SERVICE - INFO

LuK Nr: 370 0084 10 – 262mm ZA 35 x 40 x 14

CASE – JXU Series**
NEW HOLLAND – TL & TLA **
Series**

Bulletin 988 2001 550

370 0084 10

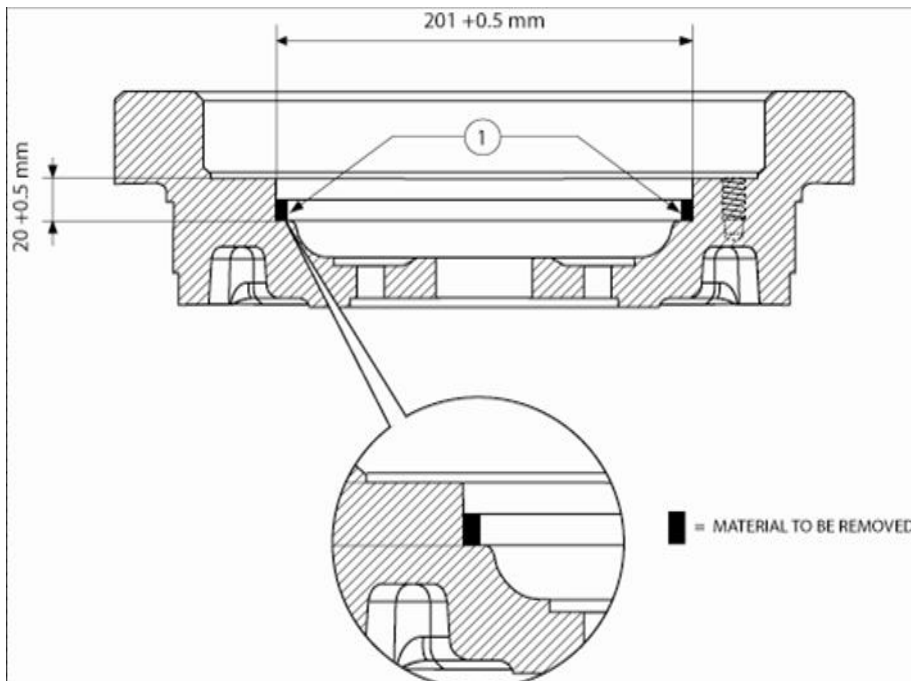
Info:	370 0084 10 Replaces / ersetzt / remplace / sustituye a / sostituisce 370 0017 10
	Please ensure that the flywheel is machined to the dimensions shown in the diagram below at point 1. New damper has increased diameter and depth.
	HUOM! Vauhtipyörä pitää koneistaa kuvan mukaisesti ennen asennusta.
	OBS! Svänghjuler bör svarjas enligt bilden nedan.
